IV. Remarks

ANNOTATED MARKED-UP DRAWING

Case No.: 10541-780 -- Visteon Case No.: V200-0538

Title: Enhanced Strength Composite Drive Shaft

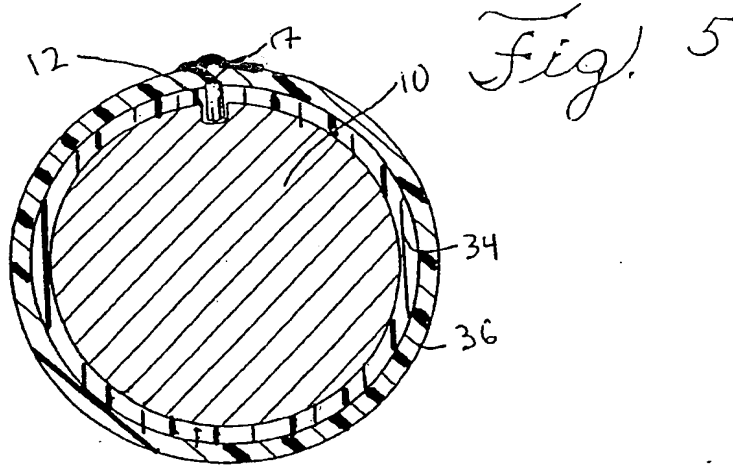
The Examiner objected to the drawings because they fail to include the approved corrections to Figures 3B and 4 which were filed July 14, 2003, and because the protruding portion of second layer 36 added to Figure 5 suggests that material was added to the top of the outer surface of layer 36.

Regarding the Examiner's objection to Figure 5, Figure 5 has been amended to show the protruding portion of the second layer 36 as a continuation of the second layer 36.

An annotated copy of Figure 5 showing the drawing corrections and an amended formal drawing correction copy of Figure 5 are included in this amendment.
